# UNITED STATES PATENT AND TRADEMARK OFFICE

APPLICATION NO.	FILING DATE	FIRST NAMED INVENTOR	ATTORNEY DOCKET NO.	CONFIRMATION NO.
09/772,234	01/29/2001	Paul G. Loubser	2001-01442	9679

# Office Action Summary

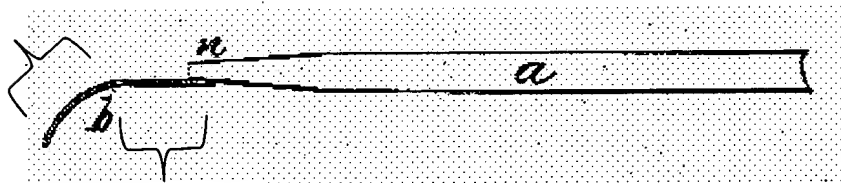
6. In response to Applicant's arguments that the proximal member and distal member of Osborne are not of the same length please see the attached drawing Figure 2 below which show the two brackets as being the same length.
